Zoning & Subdivision Committee
Tuesday, September 6, 2016, 1:30 pm

Staff Report – Village Neighborhood Section 4 Phase 1

**Subject: Village Neighborhood, Section 4, Phase 1
Final Plat Review – Comment Letter #1**

**Subject: The Courtyards at Jerome Village, Phase 1
Final Plat Review – Comment Letter #2**

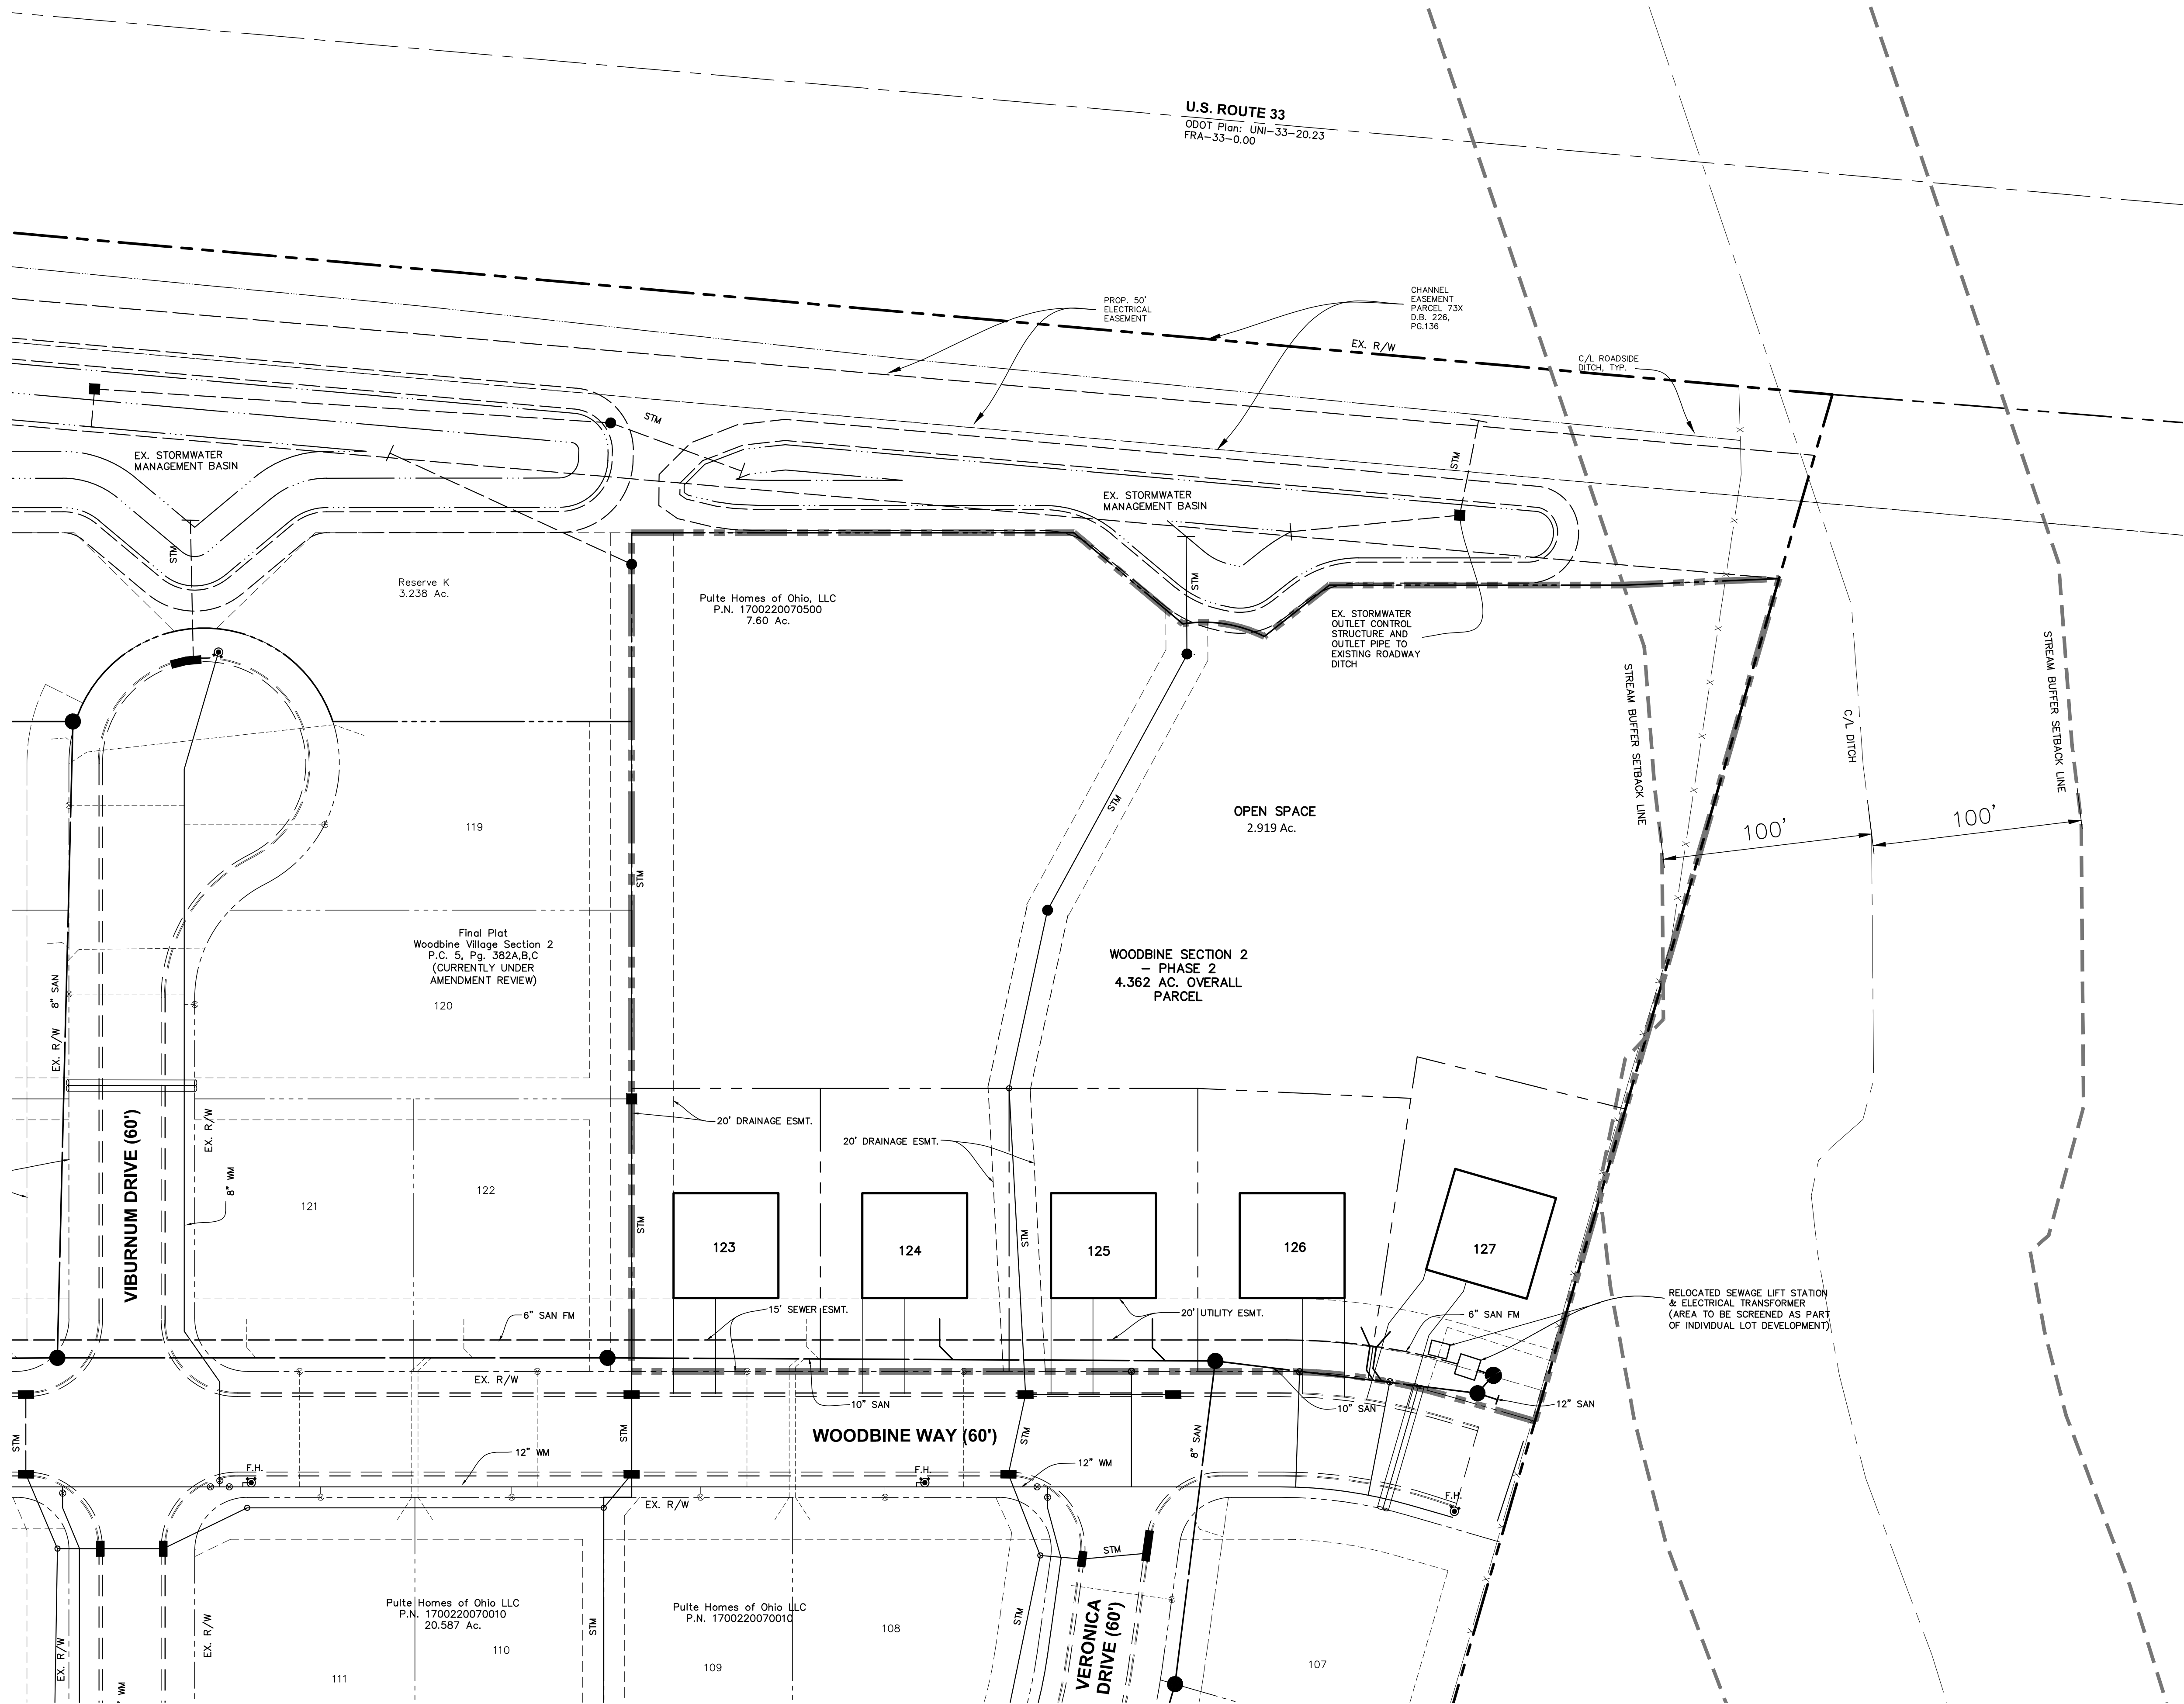
2. Sheet 4: URE electric services is from rear lot. URE easement requirements are 20 feet unless adjacent property has additional easements or right of way for ingress and egress totaling a minimum for 20 feet.

3. Sheet 4: Also 20 FT easement on North West and South East side of lot 127.
 4. Sheet 4: URE electrical facilities to cross rear lots 123, 124, 125, 126, and 127 with additional electrical facilities on the North West and South East side of lot 127 to existing primary underground 3 phase circuit.

5. Sheet 4: All easement areas must be continuous for electric facilities.
 6. Sheet 4: Include road crossing conduits at the end of Woodbine Way for future expansion of electrical facilities. (between lots 127 and 107 as noted on drawing)

1. The utility infrastructure note on sheet 4 should reference Section 2.
2. We will require an additional drainage easement along the reserve area abutting the existing stormwater basin for access and maintenance. The width of this additional easement should be no less than 15'.
3. It is recommended that a buildable lot is not placed directly behind the relocated pumpstation along Woodbine Way. In addition to the obvious concerns regarding potential odor and unsightliness, it is planned at some point that the pump station will be decommissioned after the proposed lot has been constructed and inhabited. This will result in major construction work in this lot owners front yard. We recommend revising the lot layout and creating a reserve area in the immediate vicinity of the pump station.

- g) Front Setback: 35 FT
- 4) Sheet 4 of 5 – Utility Plan
 - h) URE has existing primary underground 3 phase circuit installed in front lots. Utilizing 20 FT utility easement that is closest to house designations, ending at 35 FT setback location.

C100

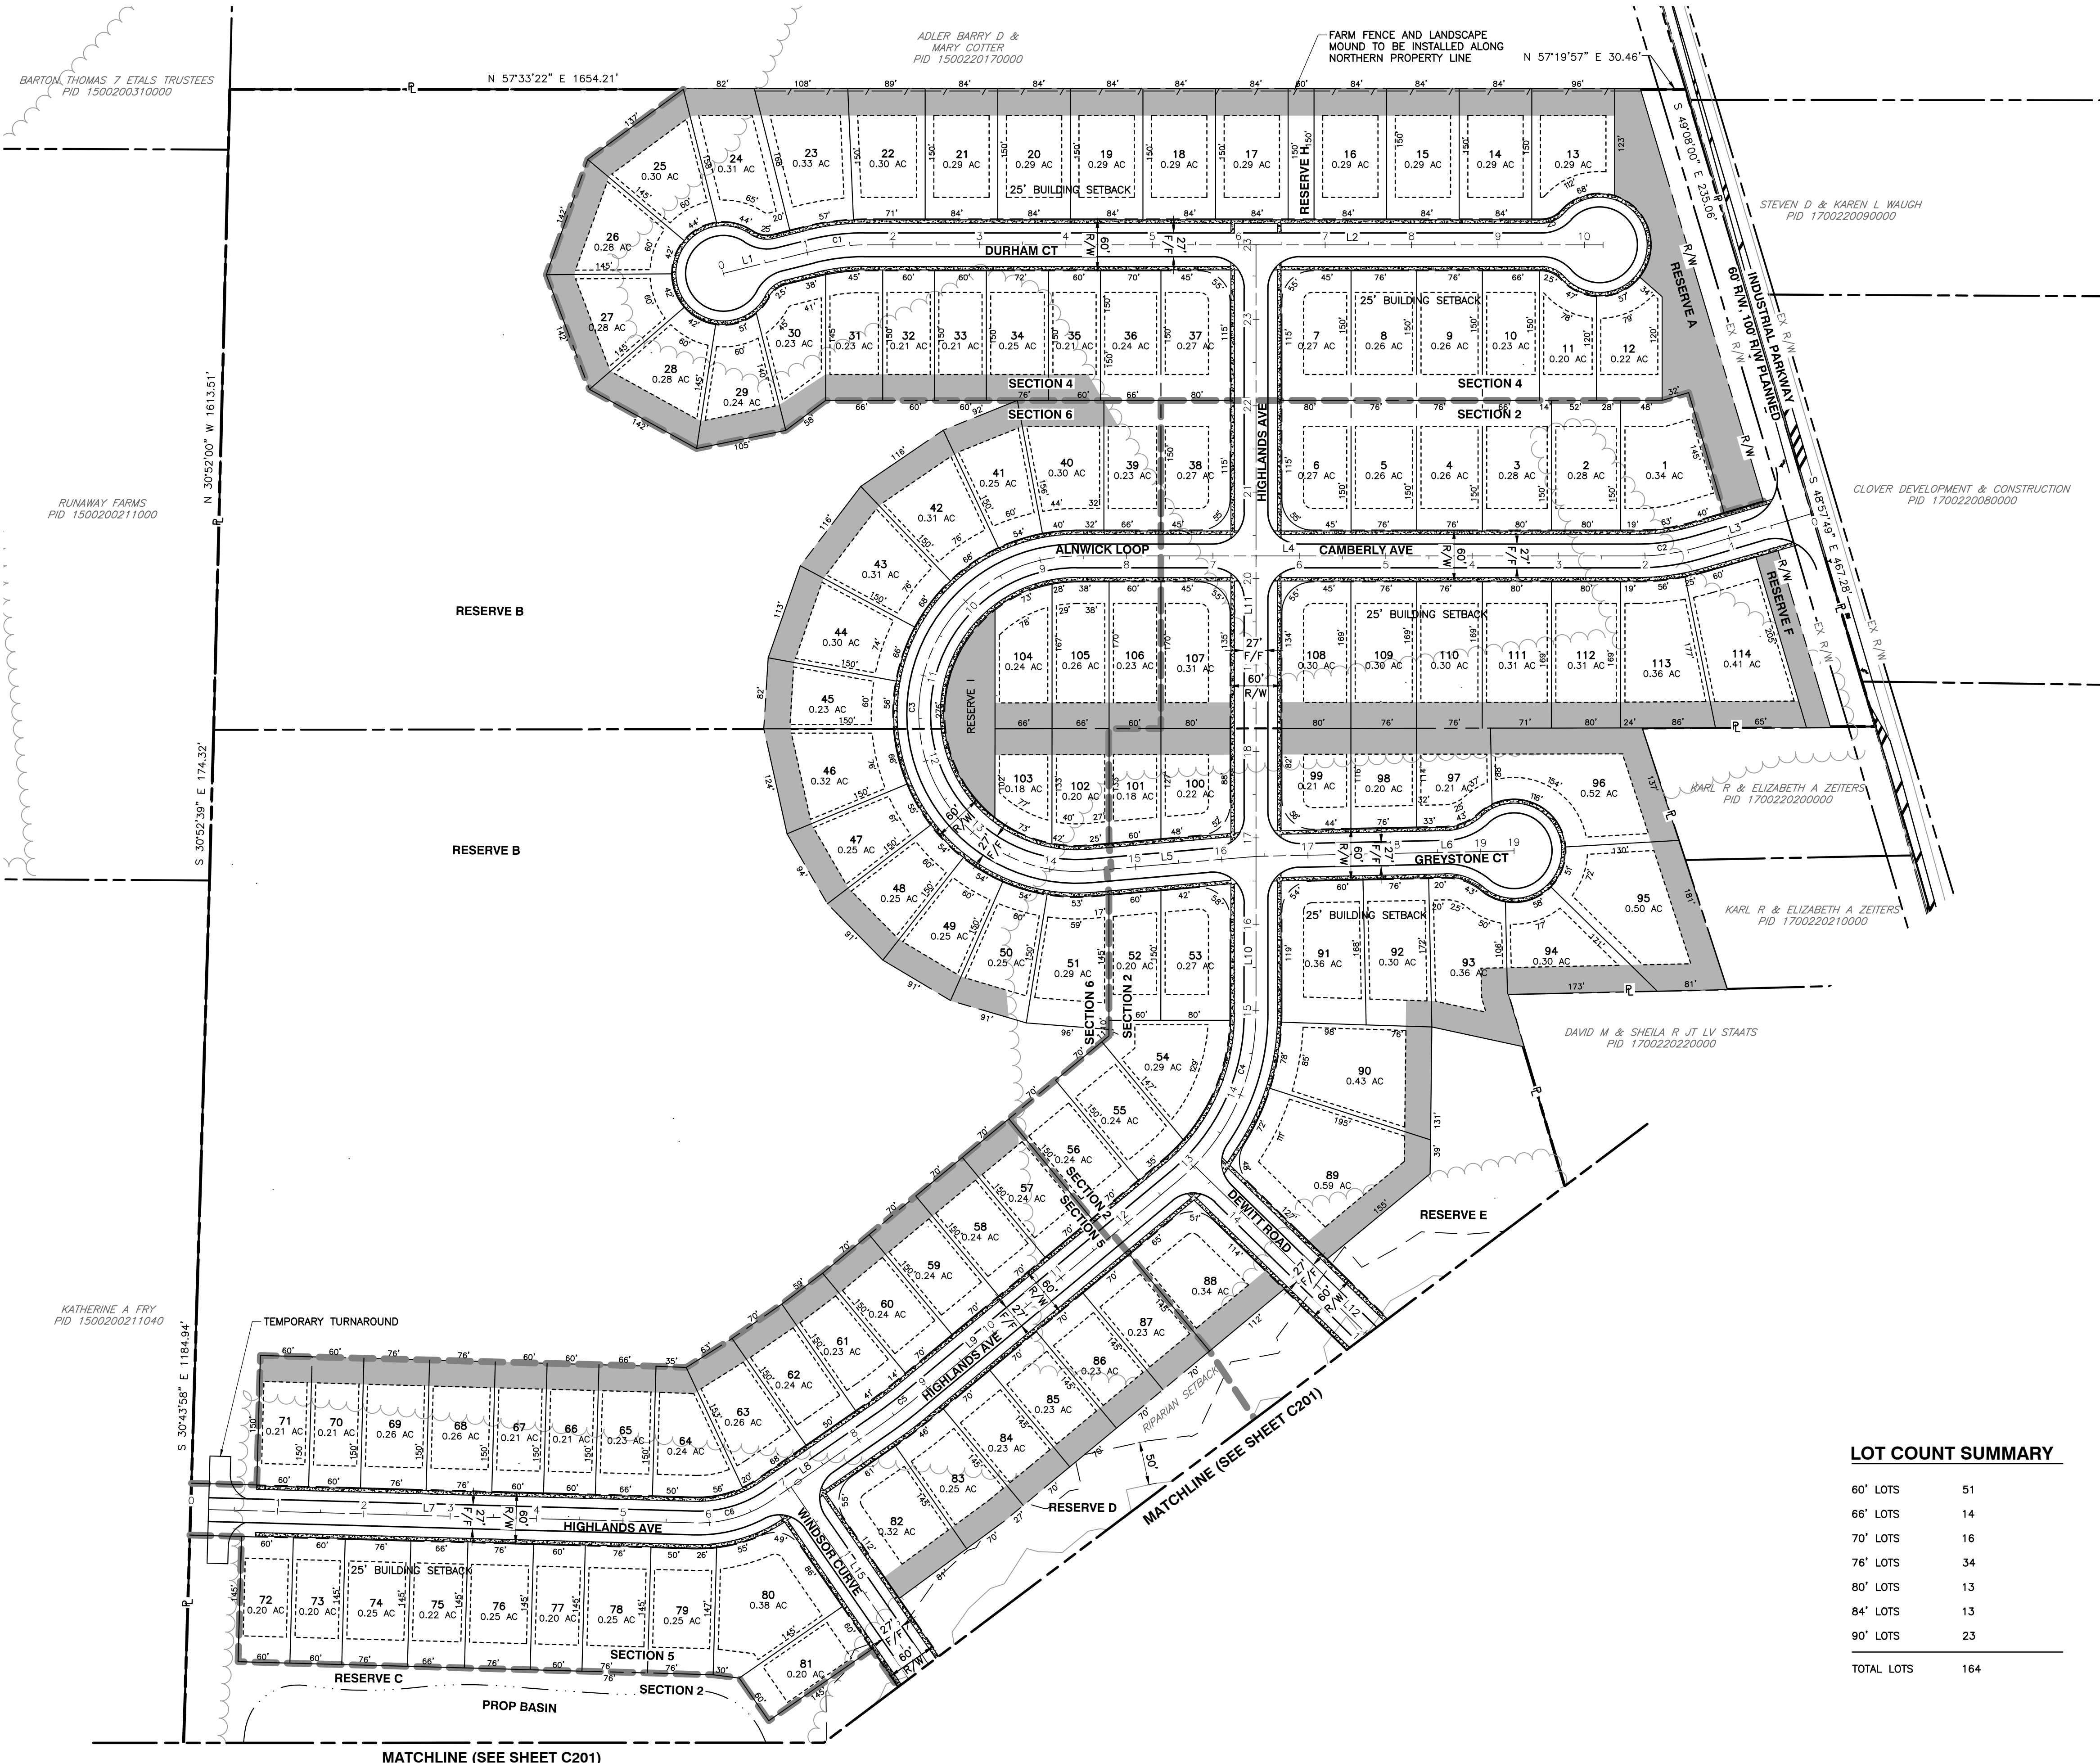
- d) Rear Setback: 30 FT
 - e) Sections: 1 - 6
- 2) Sheet 2 of 12 – C100 – Existing Conditions
 - f) Developer to install creek/stream/wetland crossing conduits (size and quantity TBD) (directional bore if applicable) 10 feet beyond creek/stream/wetland protection easements (when applicable).
